East Anglia ONE North and East Anglia TWO Offshore Windfarms

Applicants' Comments on Natural England's Deadline 6 Submissions

Applicant: East Anglia TWO and East Anglia ONE North Limited
Document Reference: ExA.AS-9.D7.V1
SPR Reference: EA1N_EA2-DWF-ENV-REP-IBR-001338

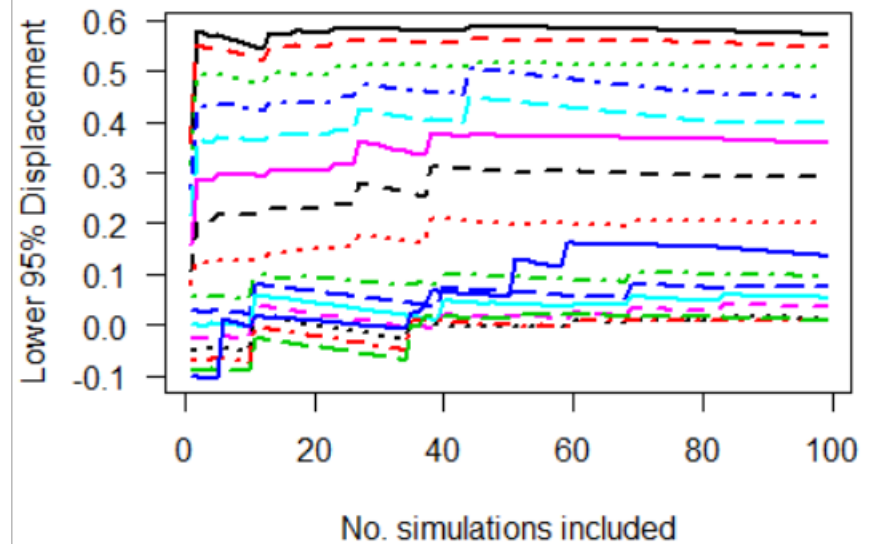
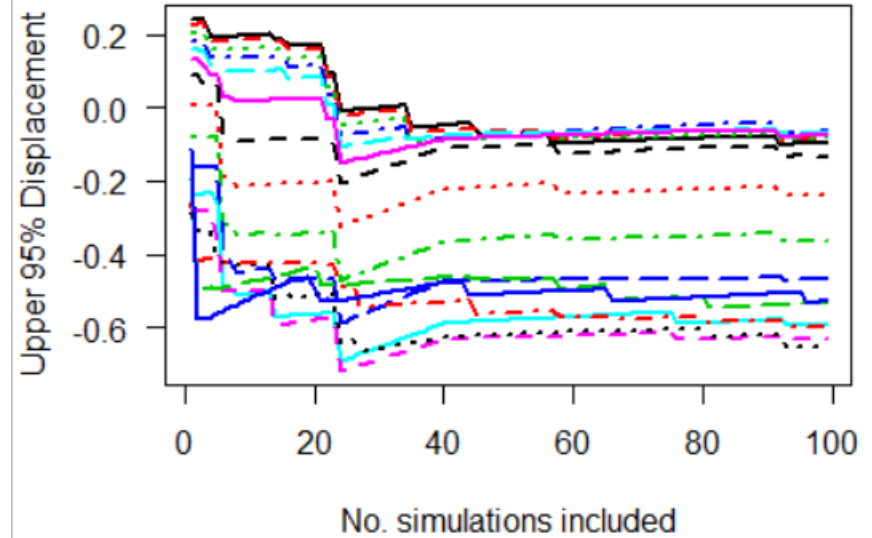
Ref	NE Comment	Applicants' Comments
ANNEX 1. Detailed technical comments on [REP5-025] Displacement of Red-Throated Divers in the Outer Thames Estuary SPA - Update		
7	<p>1) Bootstrap replicates</p> <p>Natural England welcomes the application of a bootstrap resampling method to calculate confidence intervals around the buffer zone analysis. However, the Applicant's use of only 100 bootstrap replicates appears to be arbitrary and potentially restrictive as bootstrap tests frequently utilise thousands of replicates. We advise that testing of the appropriate number of bootstrap replicates should be carried out to properly assess this uncertainty (Davidson and MacKinnon, 2000; Andrews and Buchinsky, 2002).</p>	<p>The selection of 100 bootstraps was an expedient decision to provide a response within the examination timescales, since the models are time consuming to run (this sample size took 72 hours of continuous simulation to obtain). Furthermore, the results obtained, when plotted cumulatively (i.e. the estimated upper and lower confidence estimates for each of the 16 buffer distances) calculated using 2, 3, up to 100 simulations reveals that this number is more than adequate since the lines have reached asymptotes by 40 to 70 simulations (note no ordering was applied to the bootstrap samples – these plots represent the random sequence of simulations).</p> <p>Additional simulations would make no material difference to the confidence intervals.</p>

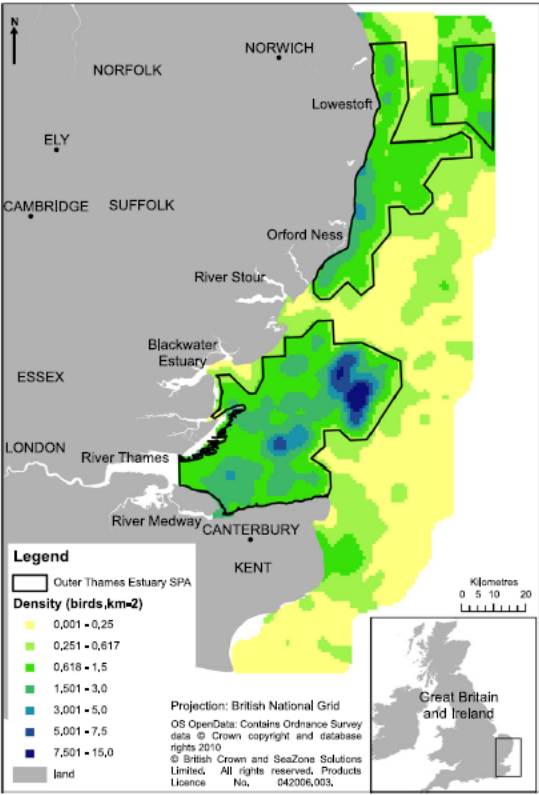
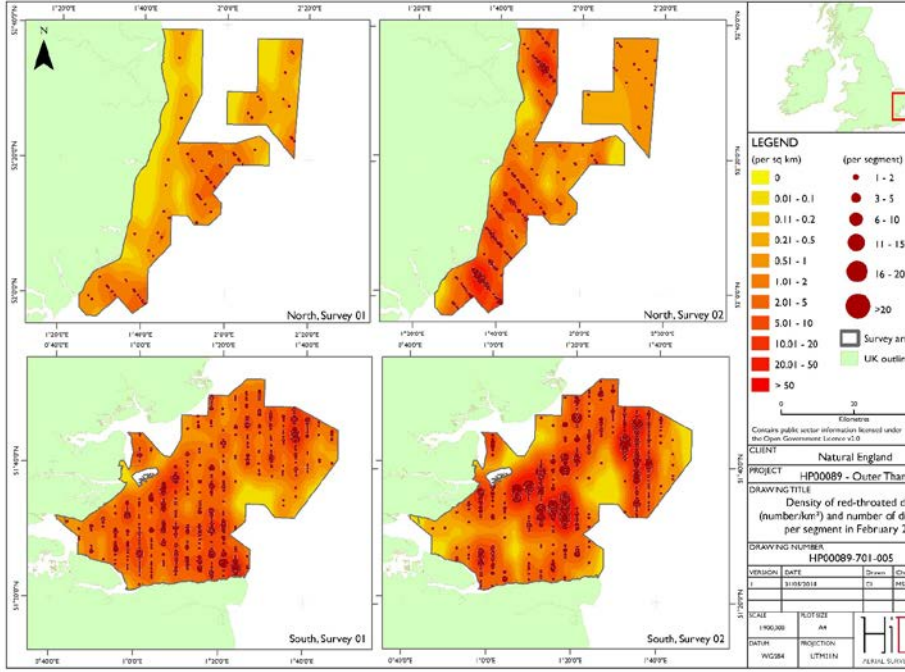
Ref	NE Comment	Applicants' Comments
8 & 9	<p>2) Accounting for Different Survey Methods</p> <p>The Applicant continues to not take account of the difference survey methods (visual and digital aerial) across the data collection period. This is a major concern for Natural England and is set out in full in Appendix 12 of our Deadline 4 [REP4-087]. If it is assumed, as the Applicant asserts, that the distribution map pre- and post-construction have accurate relative proportions, the different survey platforms may not be an issue. However, it significantly undermines the outputs of the modelling if there are differences in the ability to accurately record spatial variation in relative proportions due to the survey platform.</p> <p>One of the issues highlighted when APEM (2010) compared results obtained from visual and digital aerial surveys of the same areas conducted immediately after one another was that when considering red-throated divers alone, or all birds, the tendency for visual surveys to underestimate densities in comparison with digital aerial methods became more pronounced where digital imagery had recorded more birds. This is probably due to the ability to enumerate large numbers of birds post survey using the digital method, a procedure which is not possible for visual surveys. The assumption being made by the Applicant is that the relative abundance of birds in visual aerial surveys scale linearly with the relative abundance of birds in digital surveys (i.e. the year effect is a linear fixed effect in the model), but it is highly possible that the effect of survey platform is non-linear, as per findings in APEM (2010). Therefore, it is difficult to rule out the possibility that for the pre-construction period, largely covered by the visual aerial surveys, the highest densities could have been disproportionately under recorded, impacting the relative spatial distribution.</p>	<p>While the Applicants acknowledge these points, NE's position does not take into consideration the remarkable similarity in distribution and density reported in O'Brien et al. (2012) which used visual aerial data (top figure), and that presented in the most recent surveys (Irwin et al. 2019) which used digital surveys (lower figure).</p>

Ref	NE Comment	Applicants' Comments
		 <p>There is no indication that peak densities have been missed or flattened by the use of visual methods as implied by NE. Therefore, the Applicant does not consider there to be any indication that the effect NE suggest has actually influenced the results obtained.</p>
10	<p>It is the Applicant's view that this not an issue because:</p> <p><i>"... while the current model treats the survey data as a reliable source, at the same time the modelling allows for fluctuations over time, so the spatial predictions do not suffer as a result of changes in methodology,</i></p>	<p>This request appears to have misunderstood the methods used. The analysis was conducted using relative densities and the outputs were therefore normalised to obtain abundance estimates in the expected range of the current population size (20,000).</p>
